Regulation No. 37 (Filament lamps)

Proposal for Supplement 39 to the 03 series to Regulation No. 37

Submitted by the experts from the Working Party "Brussels 1952"*

Figure 1 Main drawing

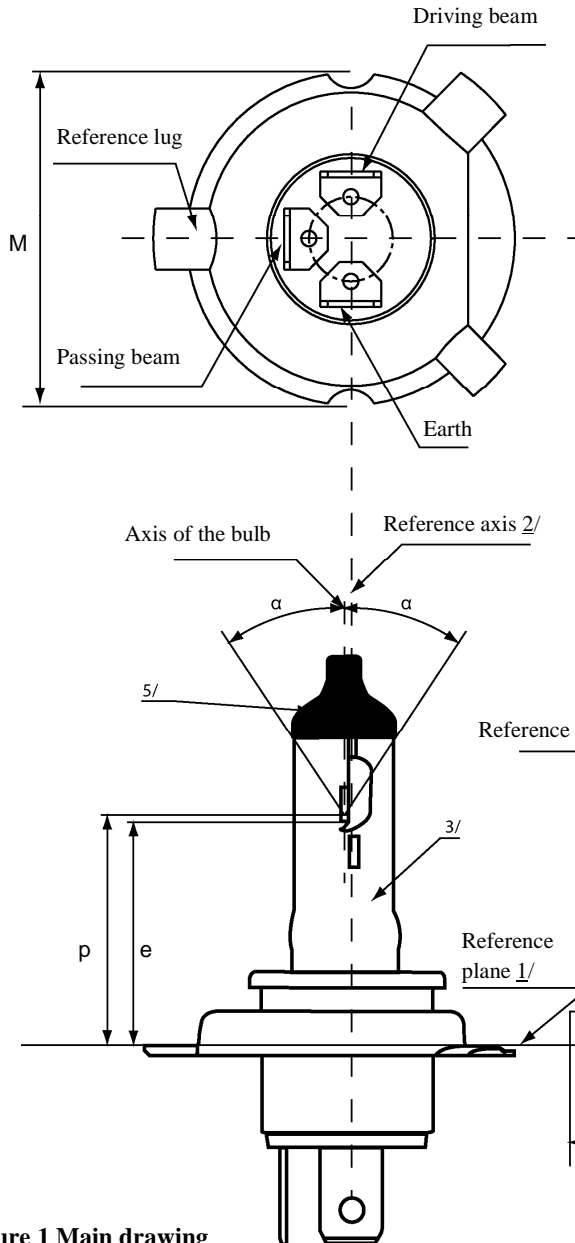
Annex 1, insert sheets H17/1 to 6 in between sheet H16/4 and sheet H6W/1, to read:

Figure 2 Maximum lamp outlines 4/

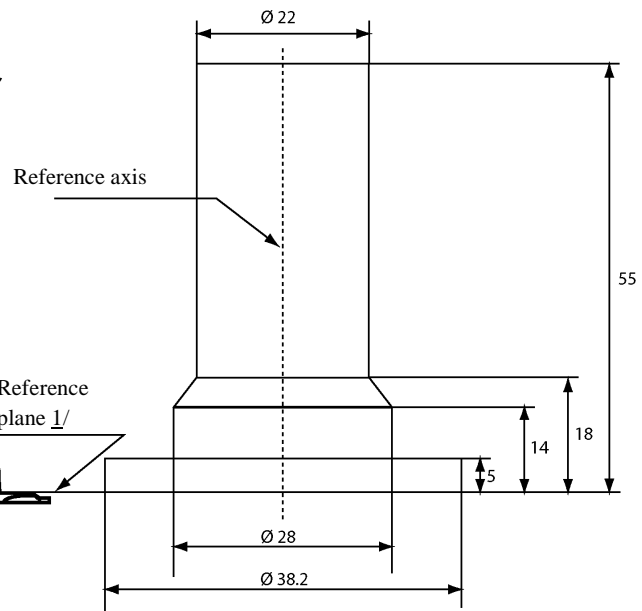
- 3/ The light emitted from standard filament lamps and from normal production lamps shall be white.
- 4/ The bulb and supports shall not exceed the envelope as in figure 2.

Position of filaments

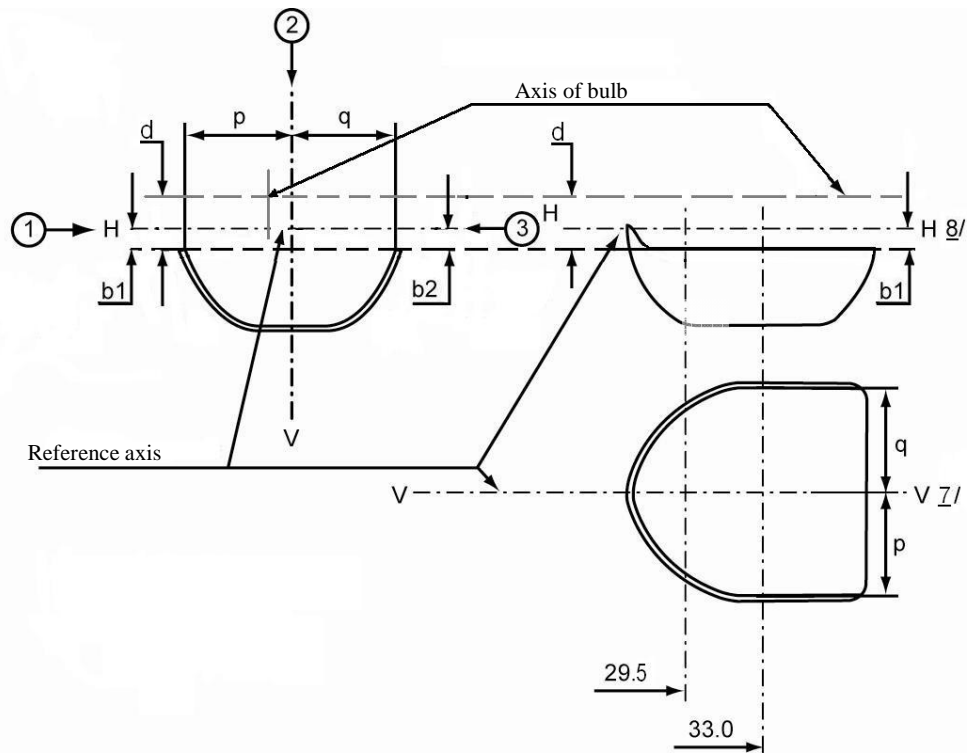
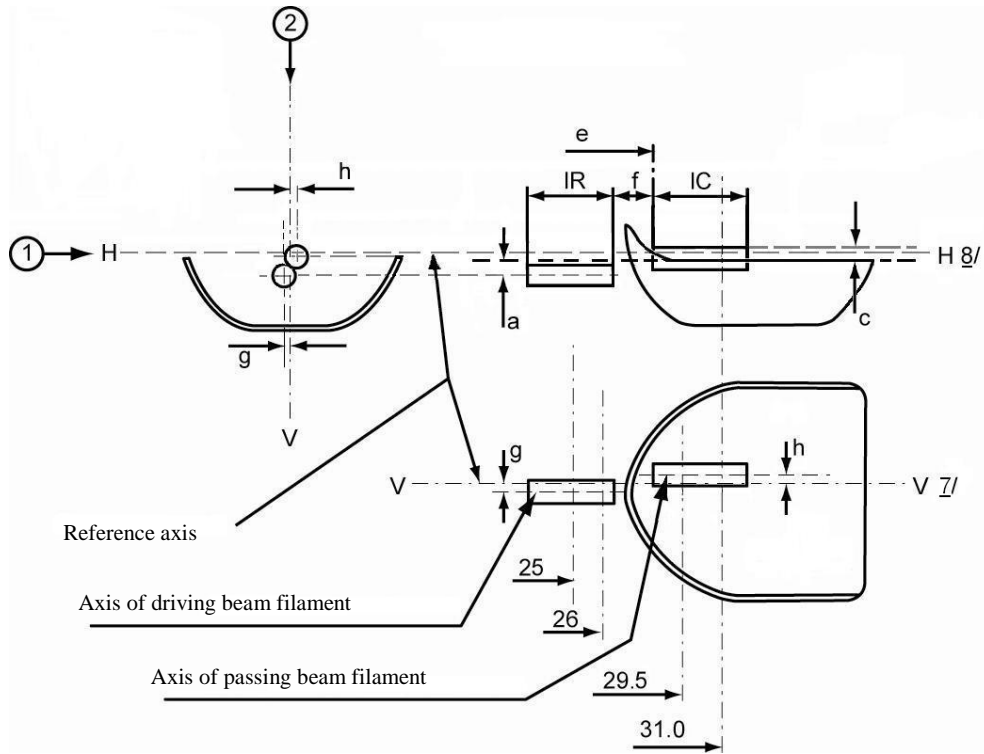
Additional explanations to sheets H17/3 and H17/4

The dimensions below are measured in three directions:

- 1 for dimensions b1, a, c, d, e, f, lR and lC.
- 2 for dimensions g, h, p and q.
- 3 for dimension b2.
